Delegate Report

File Number: DA4926/2
 Planning Application No. P153/22
 Responsible Officer: Claire Wilkinson- Senior Statutory Planner
 Attachments: N/A

<i>Application Details</i>	
APPLICANT	Bruce Maples C/- Ellen Hogan and Associates Pty Ltd
PROPOSAL	Development of land for seven (7) dwellings, subdivision of land into seven (7) lots, removal of easements and a reduction of car parking requirements
APPLICATION LODGED	10 August 2022 Amended- 17 March 2023 (from 8 Dwellings to 7 Dwellings) Amended- 10 August 2023 (Landscape Plan) Request from applicant to place file on hold- 28 November 2023
NOTICE AND SUBMISSIONS	Notices sent to twenty-eight (28) Owners/Occupiers of surrounding properties (25 October 2022 – 10 November 2022). Notice on site - Yes Six (6) objections received.
NOTICE AND SUBMISSIONS	Notices sent to thirty-six (36) Owners/Occupiers of surrounding properties (3 August 2023 – 25 August 2023). Notice on site - Yes Six (6) objections received.
CONSULTATIVE MEETING	19 October 2023
<i>Property Details</i>

PROPERTY ADDRESS	23 Elvins Street, Mansfield
LAND DESCRIPTION	Lot 1 TP645469J and Lot 1 LP22036 Parish of Mansfield
RESTRICTIVE COVENANTS	Nil
LAND AREA	1,414m ² (comb

Figure 1: Proposed site plan

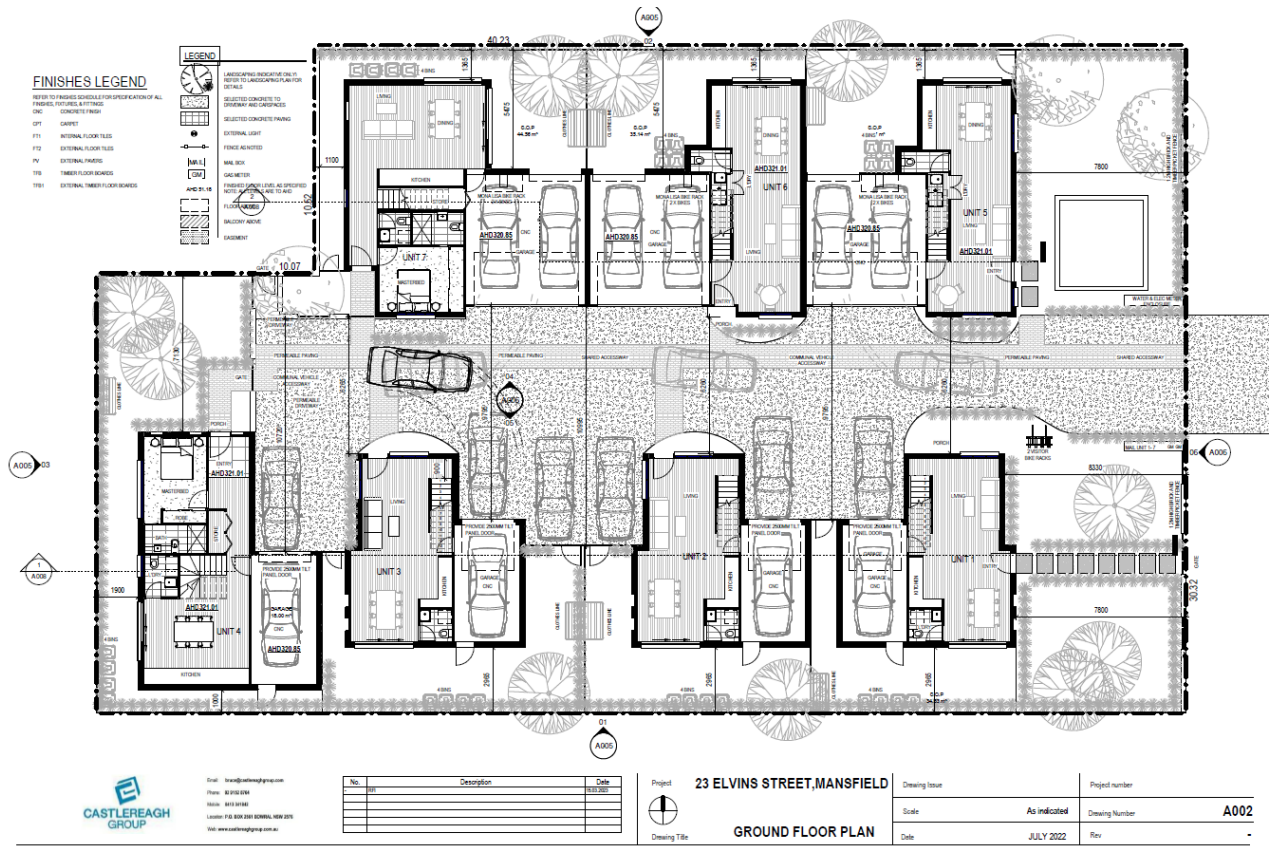
The submitted plans do not clearly delineate car parking spaces for dwellings 1-4, but it is understood that the intent is to provide a tandem car parking space to each single garage. The plans indicate that there will be car parking provided between units 2 and 3, however this is not clearly defined and it is therefore assumed that a reduction of visitor car parking is required.

The application documents provide minimal detail in relation to car parking and access, including no depiction of car parking spaces, limited swept turn paths, no dimensions of garages and no sizing of parking areas. Assessing as best as possible using Objective Trapeze to scale plans, the following matters are noted as being unsatisfactory when considered against this clause:

- a) Dwellings 1-4 do not provide car parking spaces that meet Design Standard 2 of Clause 52.06-9 in relation to size within the garage (which scale at 3m width and 5.5m length for dwellings 1-3 and 6m length for dwelling 4). These are not minor variations and call into question the functionality of these spaces. It is concerning that this variation is 'hidden' on the plans and only picked up due to questioning the size of areas shown.

- d) Design Standard 1 of Clause 52.06-9 provides criteria for vehicle passing areas at the front of a development. It is accepted that this standard does not strictly apply, as while the development includes more than 10 car parks, it does not abut a road in a TRZ2 or TRZ3, and the access is approximately 42m long in the site. However, as a matter of general functionality in a 14 car space development, cars must be able to safely maneuver and pass. The design includes a wider area at the front of the site, but when scaled appears to be 5.4m x 5.4m, which is insufficient to provide safe passing options to drivers. It is accepted that the crossover extends beyond this area such that greater length on public land will be available, however this does not mitigate the broader inadequacy of the provided passing area.

- e) The design does not clearly delineate any car parking spaces on the site, nor demonstrate dedicated provision for visitor car parking spaces. It may be assumed that car parking spaces adjacent to dwellings 2 and 3 are for visitor car parking, however there is no material on the plans that shows this, shows how large the spaces are, or if they are functional. Assuming that a reduction of the visitor car parking requirement is sought, there is no justification for this.

Figure 8: Garden area plan with areas in red that should be excluded from calculation

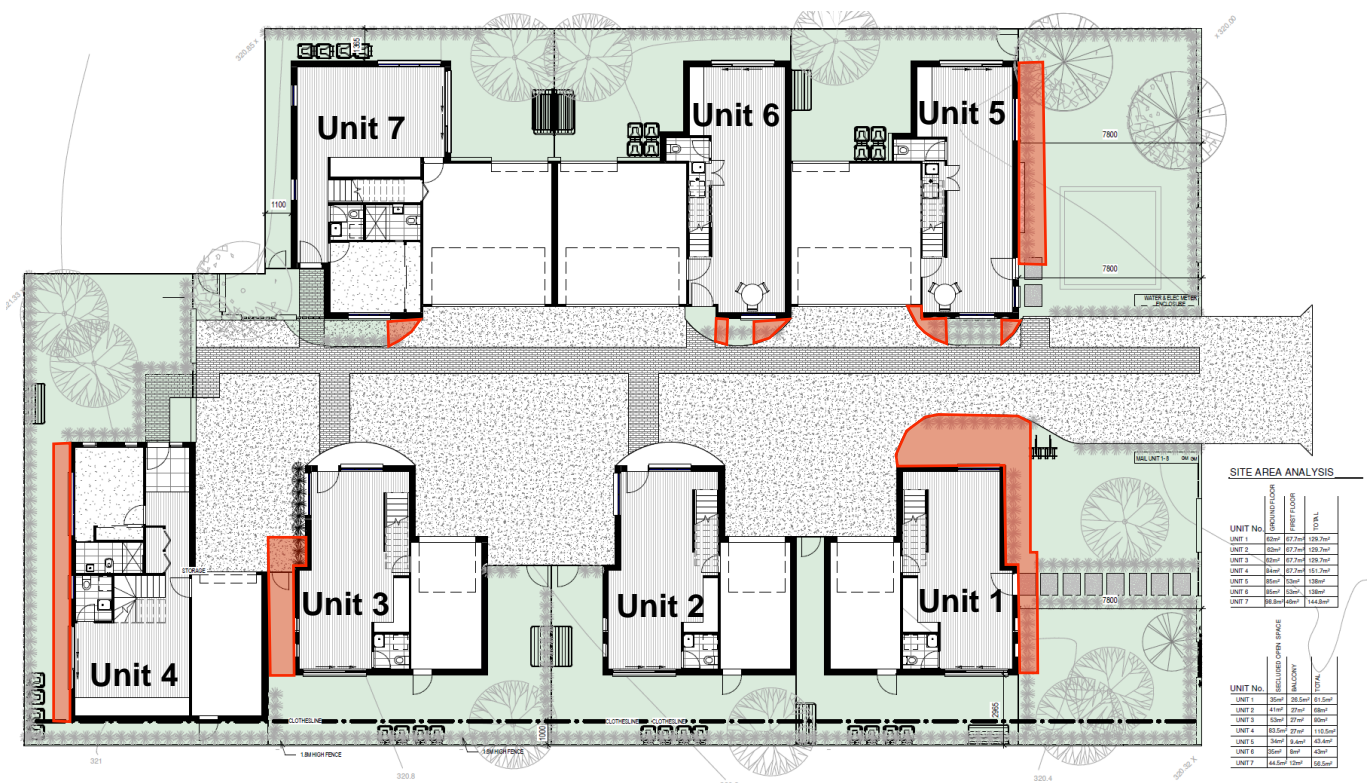
The application plans state that the area provided is 36.4%, however the garden area plan includes areas that don't meet the above definition, as annotated below:

Of the non-compliant areas, the areas in front of the driveway do not have minimum dimension of 1 metre as the highlighted points. The larger highlighted areas adjacent units 1, 2, 3 and 5 have upper level balconies or rooflines, that do not come under the exemptions in the definition.

Using Objective Trapeze to scale these areas from the plans, the highlighted areas above have the following approximate area calculations:

This would represent approximately 3.6% garden area. Assuming that the asserted 36.4% calculation on the plans is a correct depiction of the areas shown on the garden area plan, this would result in an area of approximately 32.8%, and thus would not meet the minimum garden area requirement and therefore cannot be approved in its current form.
